MIL-I-45932
AMENDMENT 2
17 OCTOBER 1997

INSERT, SCREW THREAD – THIN WALL, LOCK IN

This amendment forms a part of MIL-I-45932, dated 21 APRIL 1971, and is approved for use by all Departments and Agencies of the Department of Defense.

FIGURE 2. Toque and axial load test blocks.

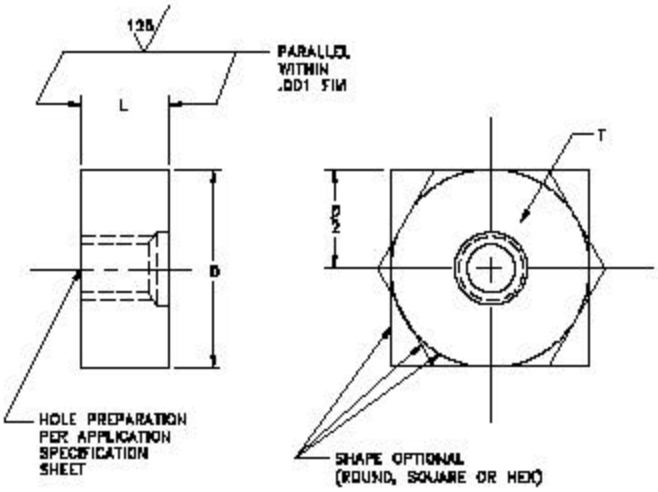
Delete in its entirety and replace with the attached page 18.

*** (a) Aluminum alloy, 2024-T4 per QQ-A-225/6 (bar) (UNS A92024).**

*** (b) Aluminum alloy, 2024-T4 per QQ-A-225/6 (bars and rods) (UNS A92024).**

*** (c) Aluminum alloy 5083-H321 per QQ-A-250/6 (UNS A95083). For pullout test (3.9.2)**

Optional material: 6061-R6 per AMS4117 or QQ-A-225/8 or 6061-T651 per AMS4128 or QQ-A-225/8.
